Agenda Item # 2

SUB-003800-2026

Ulla Compton Subdivision

- Subdivision approval to create one (1) legal lot of record from one (1) metes-and-bounds parcel.

DETAIL SITE PLAN

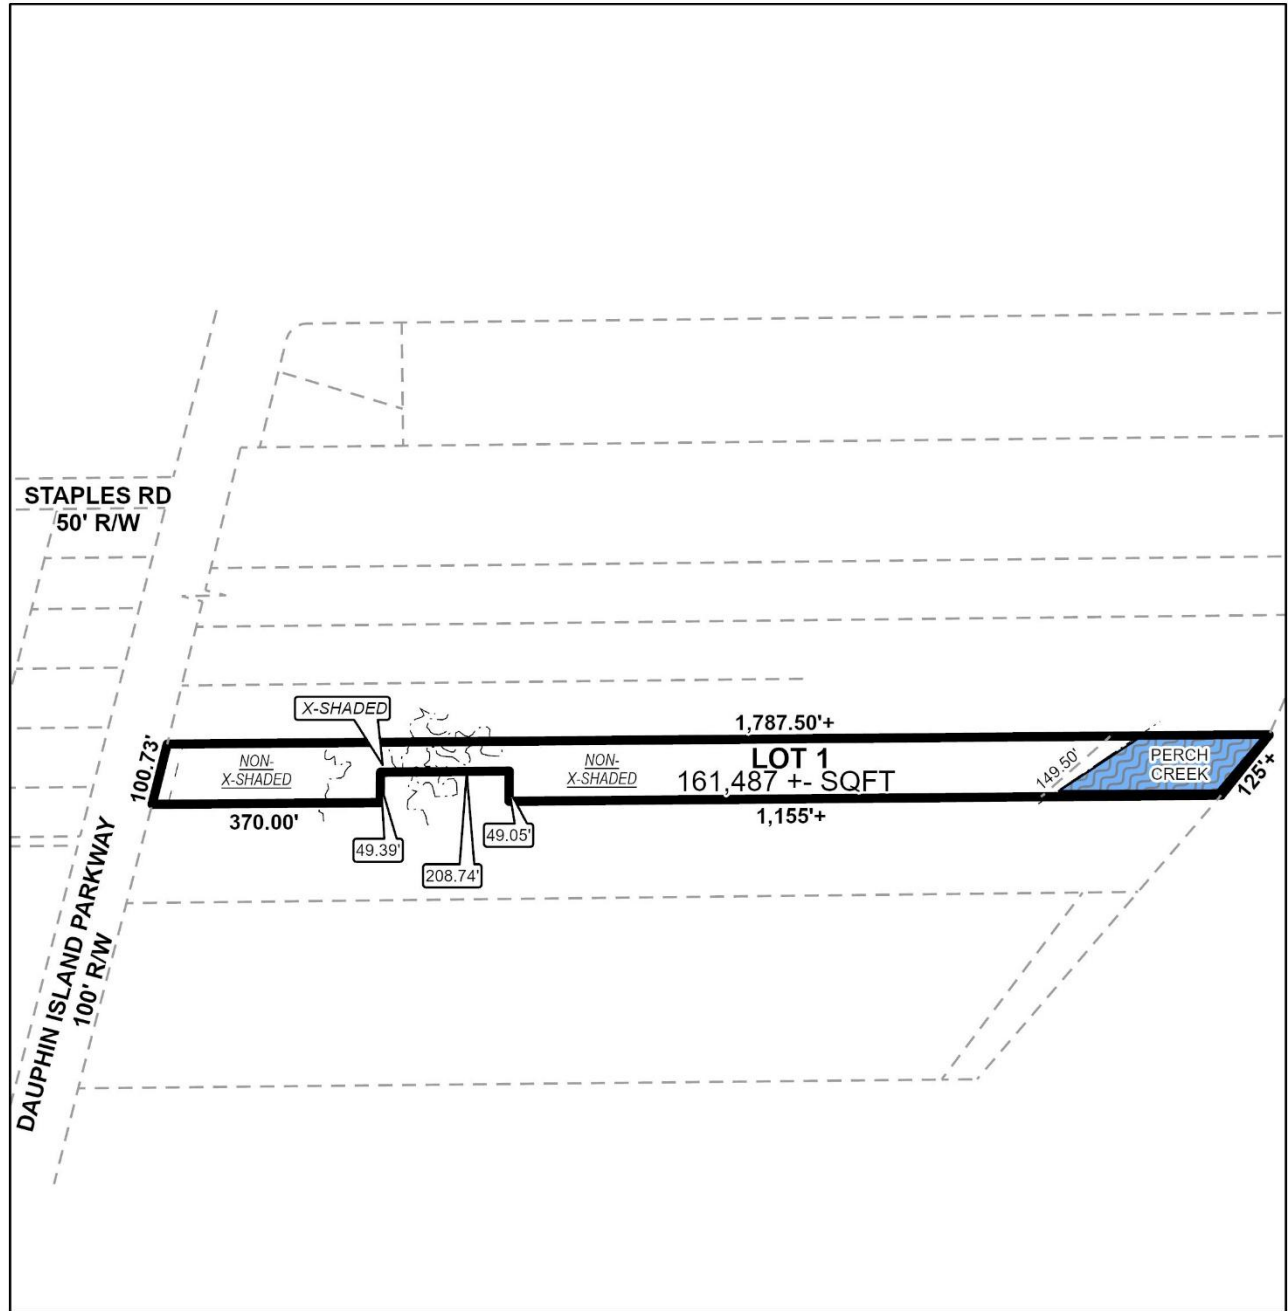
- B. Review and revise the written legal description or the drawing for two (2) of the property line segments along the south property line (371.24' and 49.00'). The written description and drawing labels do not match.

- C. Add "RIS" to the legend.
- D. Provide the actual distance between the OT and RIS on the south property line instead of "963' +/- ".
- E. National Wetlands Inventory (NWI) mapping, as shown on City of Mobile GIS information, indicates that there is potential for wetlands within the property or properties shown on this plat. Show and label the delineated wetlands or provide a note stating that the wetlands shown on this plat are scaled from the NWI data and have not been delineated.

- F. Provide a note that a 25' riparian buffer may be required, during development, along the edge of anything considered by ADEM to be a water of the state.

- G. Show and label the MFFE (Minimum Finished Floor Elevation) on each lot that contains an A, AE, or X (shaded) flood zone designation. BFE = 10.
- H. Revise ENGINEERING COMMENTS #1 to read "As shown on the 1984 aerial photo LOT 1 will receive the 4,000 SF credit provided to the original SF residential lot as follows: LOT 1 – 4000 sf. Stormwater detention will be required for any additional impervious area that exceeds the allowable credit for that LOT.

The lot fronts Dauphin Island Parkway, a Principal Arterial Street requiring a 100-foot-wide right-of-way at this location. The preliminary plat illustrates a 100-foot right-of-way width along Dauphin Island Parkway, and, if approved, this should be retained on the Final Plat.

The lot is properly labeled with the lot area in both square feet and acres on the preliminary plat, as required by Section 5.A.2(e).4. of the Subdivision Regulations. If approved, this information should be retained on the Final Plat; alternatively, a table providing the same data is acceptable.

A 25-foot minimum front yard setback is illustrated along Dauphin Island Parkway, as required by Section 6.C.8. of the Subdivision Regulations and Article 2, Section 64-2-5.E. of the UDC. This information should be retained on the Final Plat, if approved.

The proposed lot meets the minimum 60-foot width requirement of Section 6.C.2(b)(4) of the Subdivision Regulations for commercial lots, but the Subdivision Regulations state that the maximum depth of any lot exclusive of unusable land shall not be more than 3.5 times the width of the lot at the building setback line. The proposed lot exceeds this requirement. Such lot designs are not uncommon within the vicinity of the subject site; therefore, if approved, a waiver of Section 6.C.3. of the Subdivision Regulations will be required.

The site is within the Peninsula Overlay. As such, development of redevelopment of the site is subject to the applicable provisions of Article 12 of the Unified Development Code. A note stating such should be placed on the Final Plat, if approved.

1. Retention of the 100-foot right-of-way width along Dauphin Island Parkway;
2. Retention of the lot sizes in both square feet and acres, or provision of a table on the Final Plat with the same information;
3. Retention of the 25-foot minimum building setback line along Dauphin Island Parkway;
4. Placement of a note on the Final Plat stating the site is within the Peninsula Overlay and development or redevelopment of the site is subject to the applicable provisions of Article 12 of the Unified Development Code;
5. Compliance with all Engineering comments noted in this staff report;
6. Placement of a note on the Final Plat stating all Traffic Engineering comments noted in this staff report;
7. Compliance with all Urban Forestry comments noted in this staff report; and,
8. Compliance with all Fire Department comments noted in this staff report.
